QUIKTRIP NO. 4245 SITE PLAN AND CONDITIONAL USE

3rd Submittal
 Comments in green were made by PW Engineering reviewer Sergio Um. Please reach out to him at sum@auroragov.org for any comments or questions.

COVER

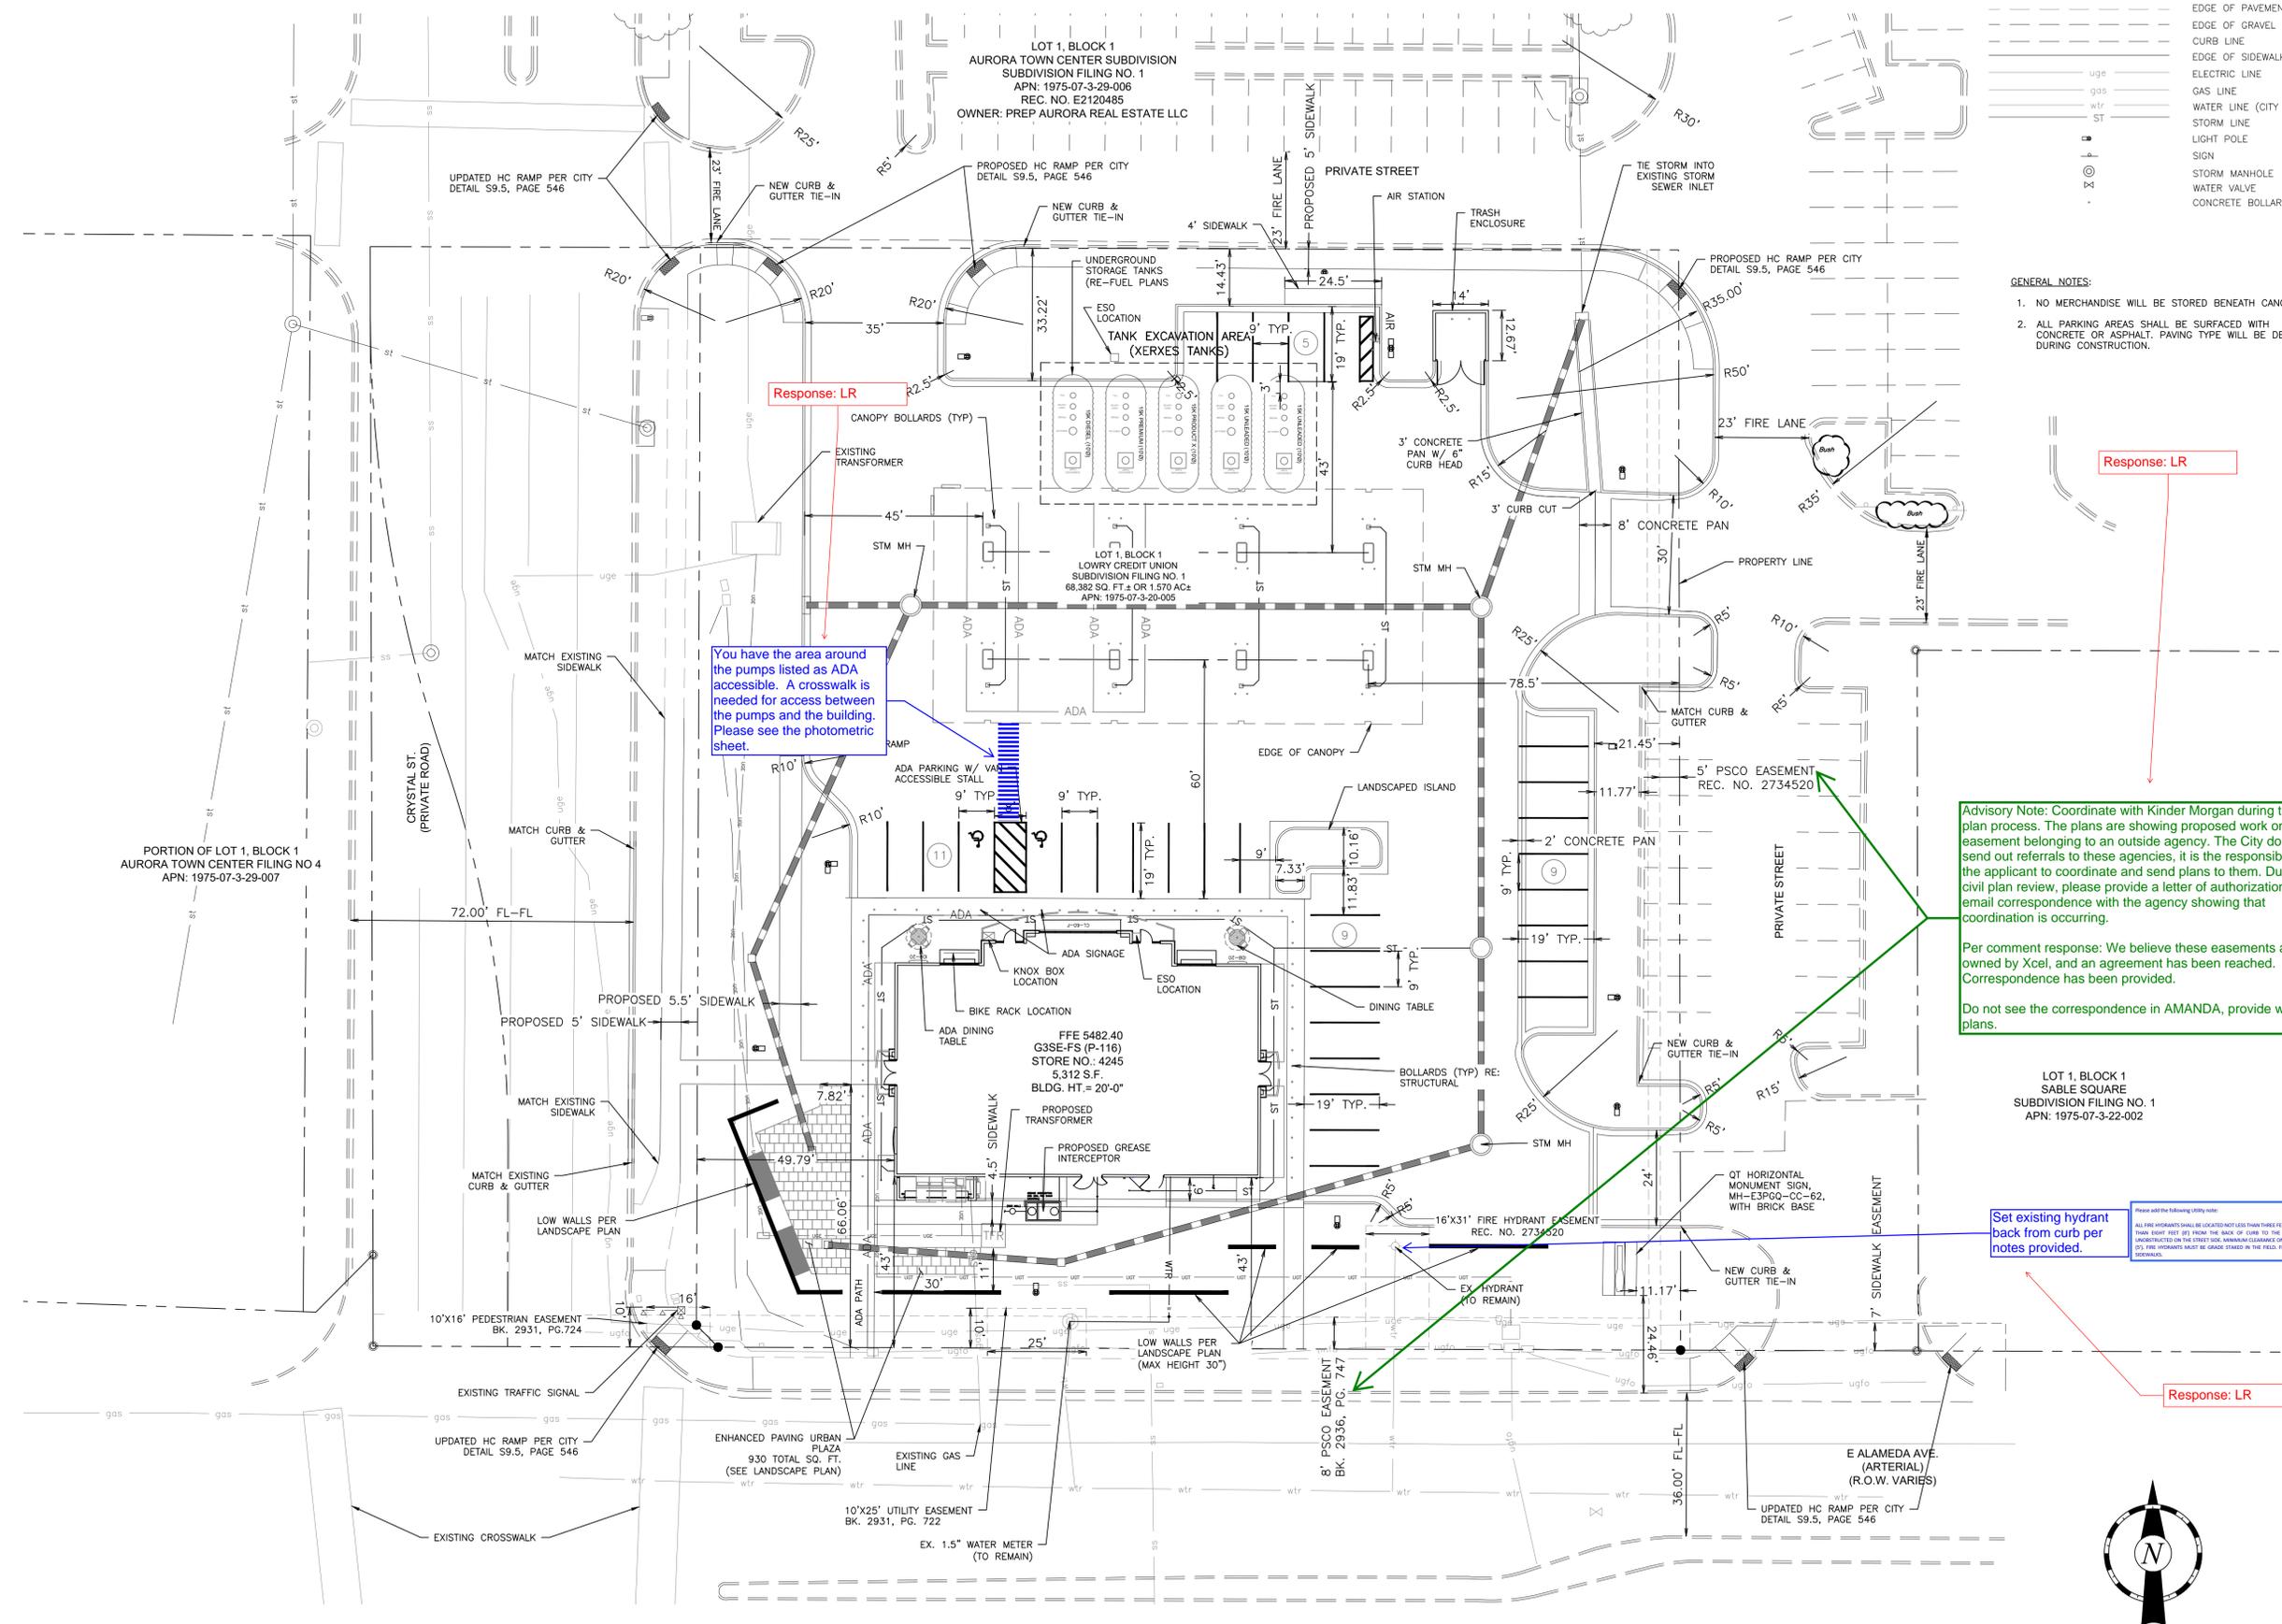
Advisory Note: Coordinate with Kinder Morgan during the civil plan process. The plans are showing proposed work on an easement belonging to an outside agency. The City does not send out referrals to these agencies. It is the responsibility of the applicant to coordinate and send plans to them. During the civil plan review, please provide a letter of authorization or email correspondence with the agency showing that coordination is occurring.

Per comment response: We believe these easements are owned by Xcel, and an agreement has been reached. Correspondence has been provided.

Do not see the correspondence in AMANDA, provide with civil plans.

Set existing hydrant back from curb per notes provided.

You have the area around the pumps listed as ADA accessible. A crosswalk is needed for access between the pumps and the building. Please see the photometric sheet.

Response: LR

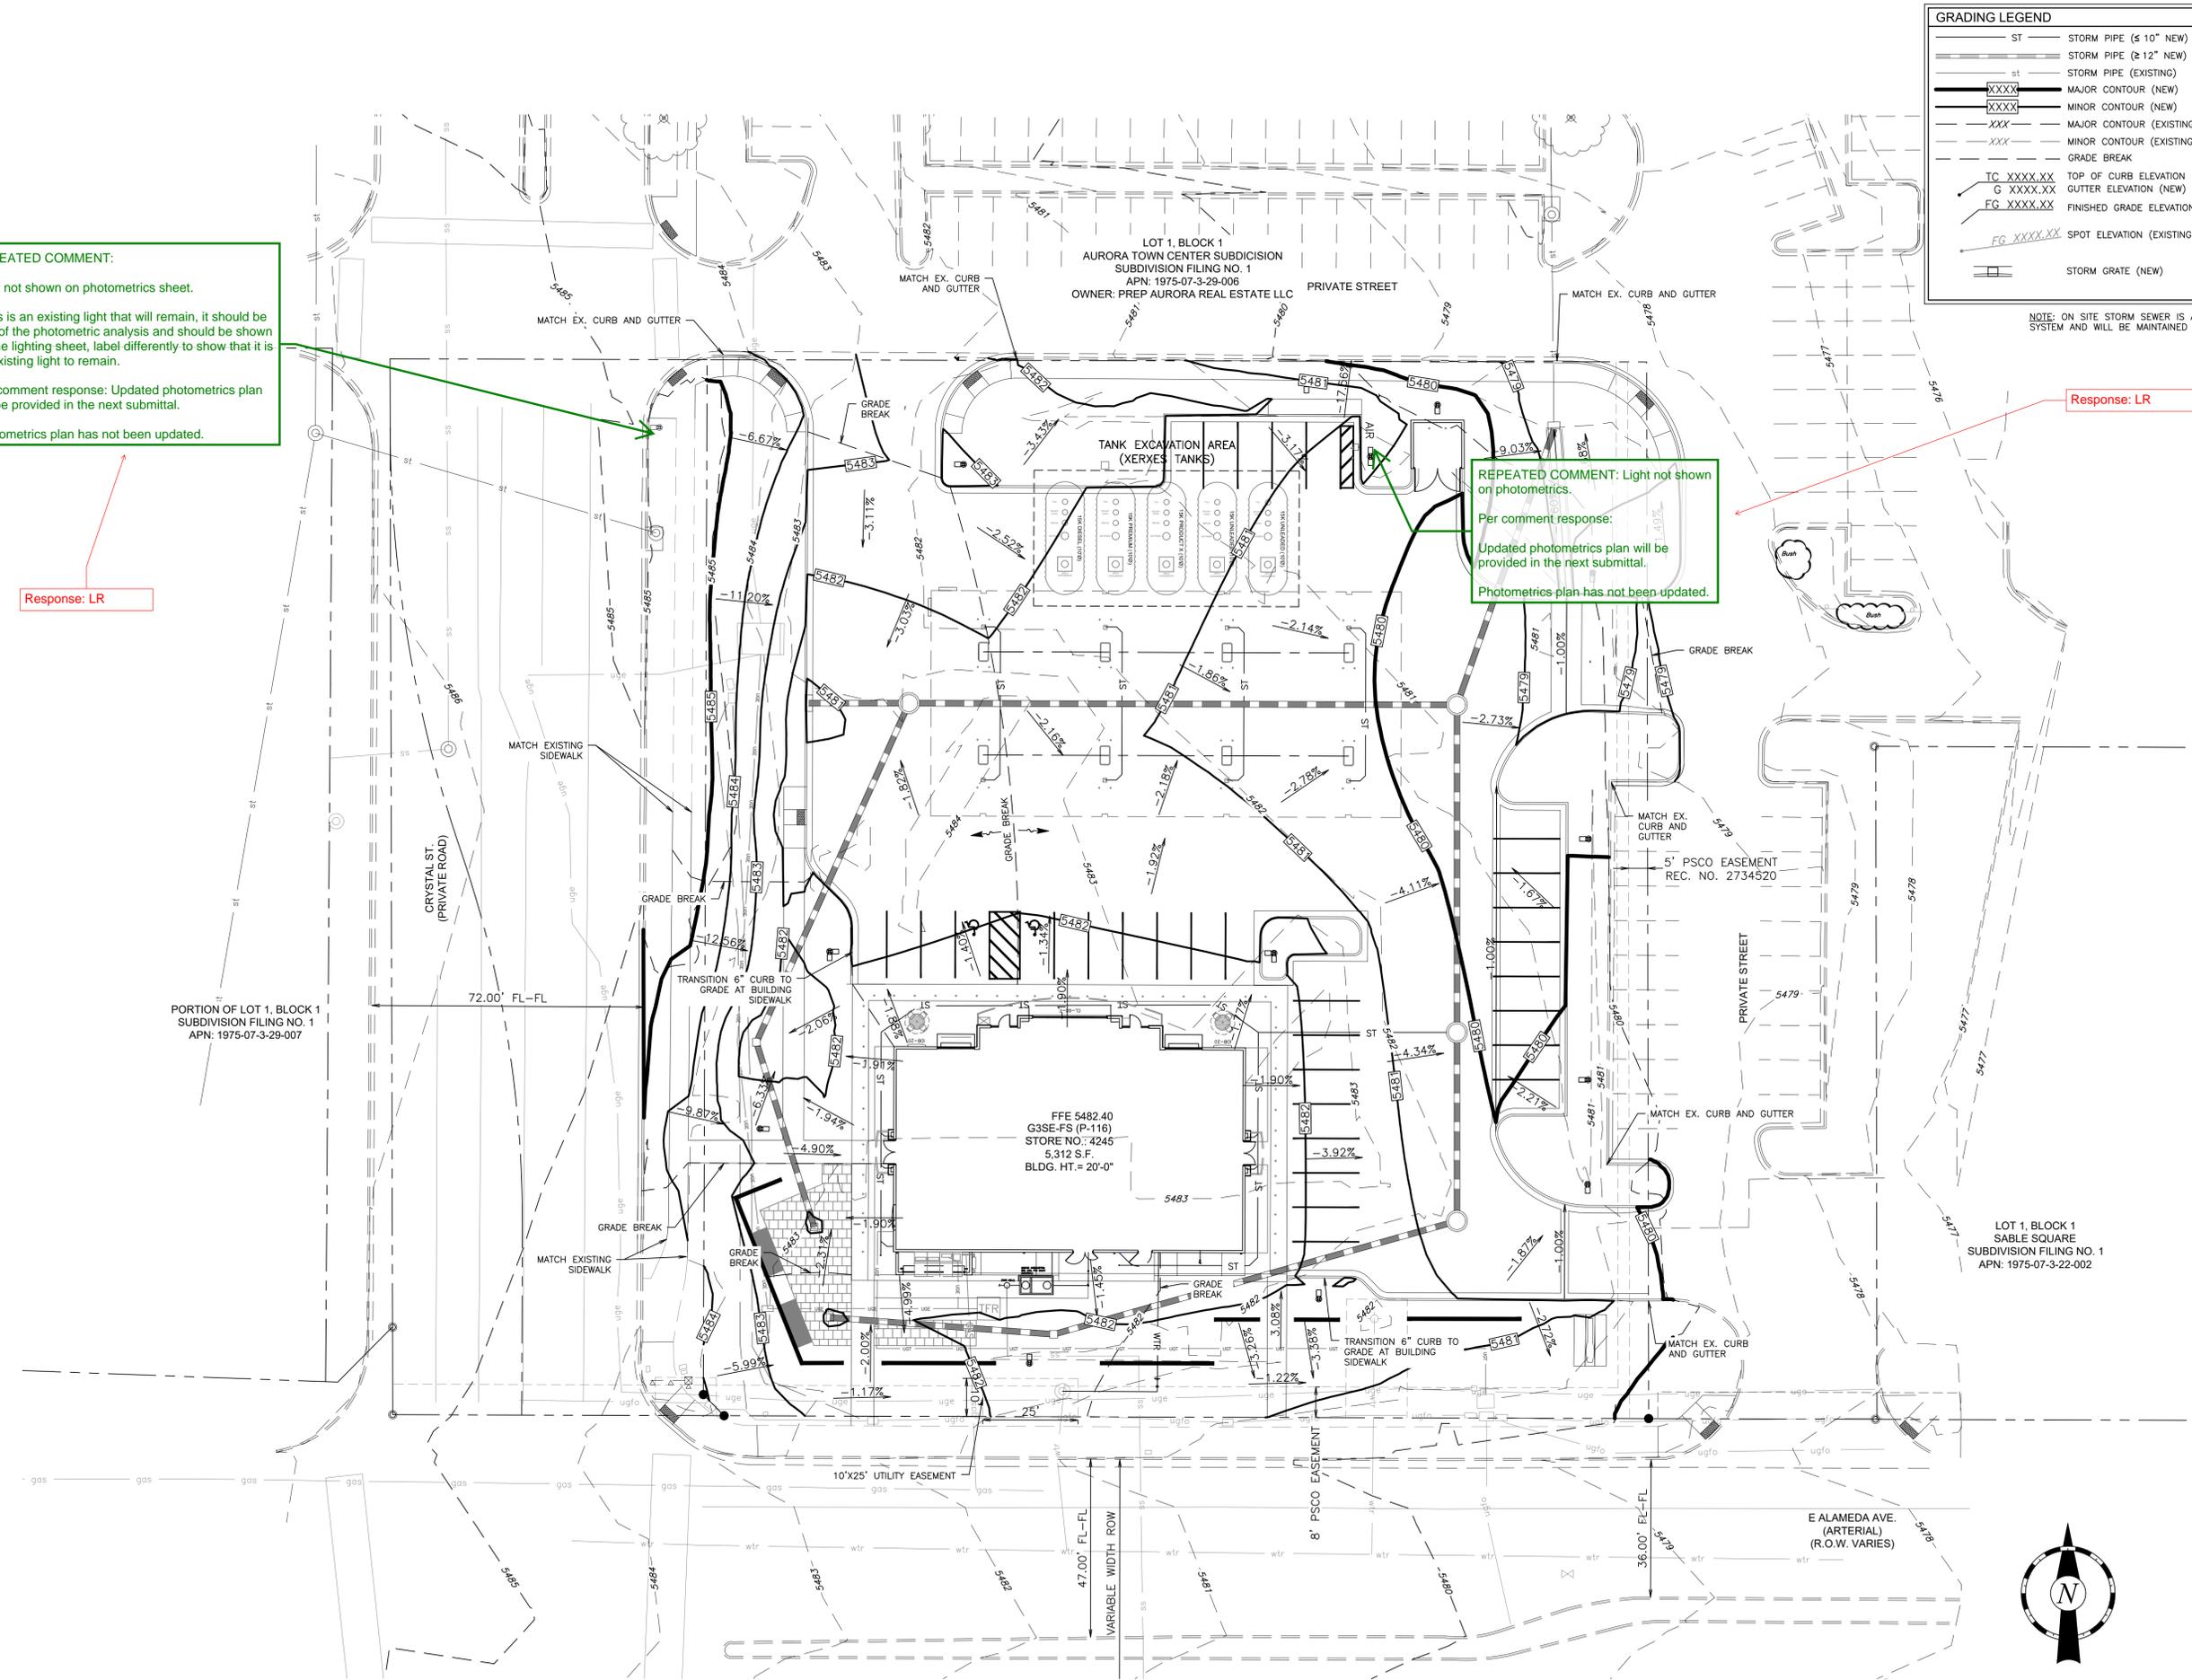
REPEATED COMMENT: Light not shown on photometrics.
 Per comment response: Updated photometrics plan will be provided in the next submittal.
 Photometrics plan has not been updated.

REPEATED COMMENT:
 Light not shown on photometrics sheet.
 If this is an existing light that will remain, it should be part of the photometric analysis and should be shown on the lighting sheet, label differently to show that it is an existing light to remain.
 Per comment response: Updated photometrics plan will be provided in the next submittal.
 Photometrics plan has not been updated.

Response: LR

Response: LR
